Re: Riverkeeper, Inc.'s Comments on the U.S. Nuclear Regulatory Commission's Generic Environmental Impact Statement for License Renewal of Nuclear Plants, Supplement 38, Regarding Indian Point Nuclear Generating Unit Nos. 2 and 3, Draft Report for Comment, Docket Nos. 50-247 and 50-286

Riverkeeper, Inc. ("Riverkeeper") hereby respectfully submits the following comments on the U.S. Nuclear Regulatory Commission Staff's ("NRC Staff") Generic Environmental Impact Statement for License Renewal of Nuclear Plants, Supplement 38, Regarding Indian Point Nuclear Generating Unit Nos. 2 and 3, Draft Report for Comment (also known as the Draft Supplemental Environmental Impact Statement, and hereinafter referred to as "DSEIS"). Notice of availability of and opportunity to comment on the DSEIS was published in the Federal Register on December 22, 2008.¹

Figure 2: The standardised juvenile index for white catfish in the Hudson, showing a decreasing trend though time. The trend is significant (a = -0.0136, b = 27.216, F = 14.0414, p = 0.0008) (Seaby and Henderson, 2007)

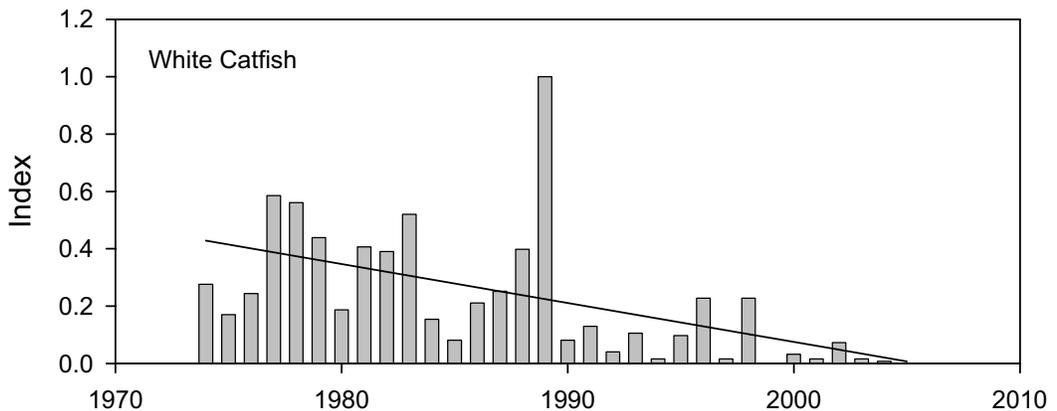
The Year Class Reports for the Hudson River Estuary Monitoring Program shows that, river-wide, juvenile white catfish have been in a steep decline in abundance since 1990 (Figure 2).

It is therefore unsurprising that in Table 4-4 (see Figure 1) the population line of evidence is for a ‘Large’ potential adverse impact. The trend shown in Figure 2, which is statistically significant, certainly seems to correspond with the definition of Large given on page H-33, NUREG-1437, Vol 2:

Figure 3: The standardised juvenile index for weakfish in the Hudson showing a decreasing trend though time. The trend is significant ($a = -0.0155$, $b = 31.0218$, $F = 7.0811$, $p = 0.0134$) (Seaby and Henderson, 2007)

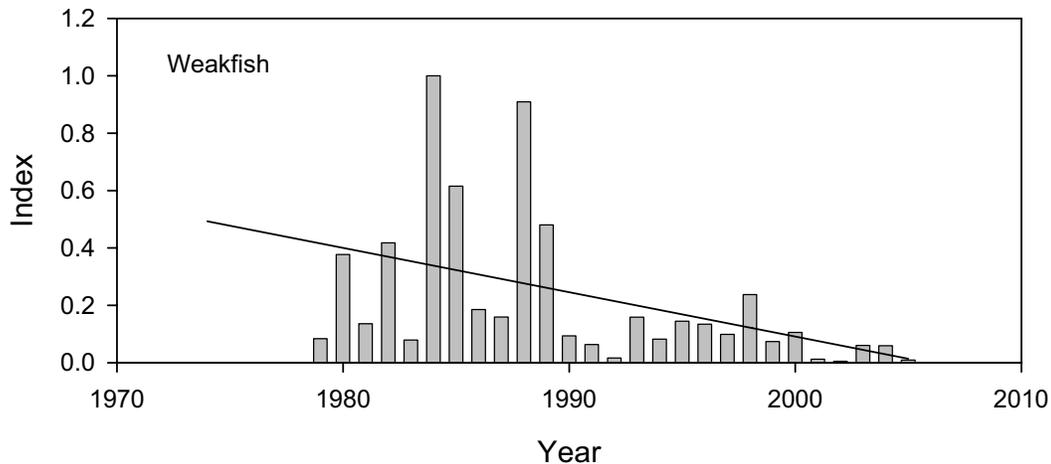
Like white catfish, weakfish have also shown river-wide a steep decline in abundance since 1990 (Figure 3). However, unlike white catfish, for this species Table 4-4 classifies the population line of evidence as ‘Small’.

A ‘Small’ potential for adverse impact is defined on page H-32 vol 2 as:

Figure 5: The standardized juvenile index for rainbow smelt in the Hudson.

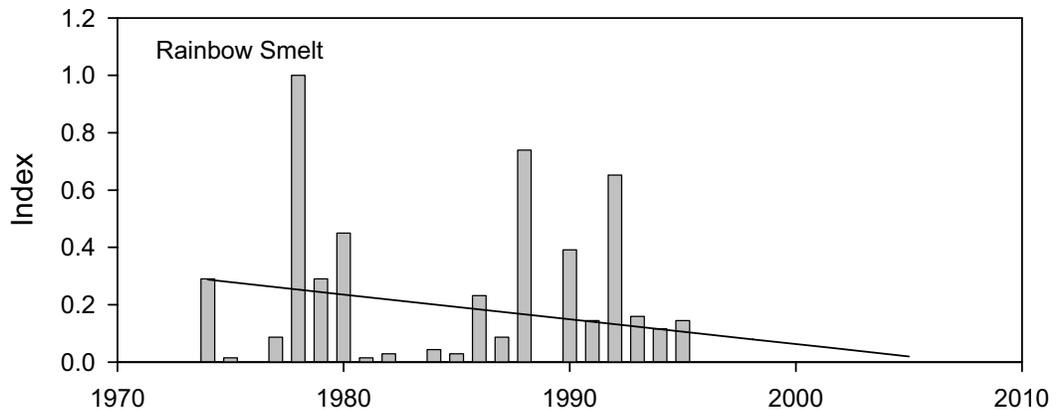
Juvenile rainbow smelt have disappeared from the survey since the mid 1990s (Figure 5), and it is therefore unsurprising that Table 4-4 assesses the population line of evidence as ‘Large’. However, the impact of Indian Point 2 and 3 is assessed as moderate because the strength of connection is assessed as ‘Medium’.

Examination of Table I-32 (Figure 4) shows why the overall impact is only 'Moderate'. This table shows that both the impingement and entrainment of rainbow smelt has been appreciable, and entrainment has been given the highest score possible of 4. However, the strength of connection is only medium because both the impingement and entrainment prey scores are 1. The reason for this is stated in NUREG-1437, Vol. 2 page I-41.

Figure 6: The standardised juvenile index for tomcod in the Hudson showing a decreasing trend though time. (Seaby and Henderson, 2007)

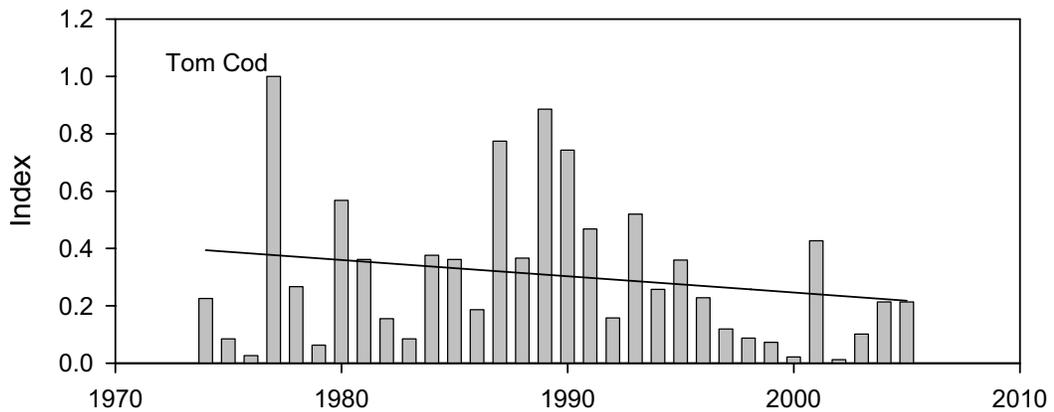
Examination of Table I-32 (Figure 4) shows that a number of the RIS species have a prey score for impingement and entrainment of 1, and thus are unlikely to score highly for the strength of connection. This feature of the scoring protocol is thus central to the final outcome. The Atlantic tomcod makes a telling further example. The tomcod population shows considerable year-to-year variation, but appears to be in long-term decline (Figure 6). The average standardised index from 1975 until 1995 is 0.158; in comparison the index for the last ten years of sampling (1996-2005) is only 0.0617. In the last 10 years, only 2001 produced a good recruitment, although there are signs of a recent slight improvement in tomcod numbers.

While the population line of evidence for a decline is large, the invertebrate prey of this species is primarily responsible for the low-to medium strength of connection and the final conclusion that the impact is small to moderate.
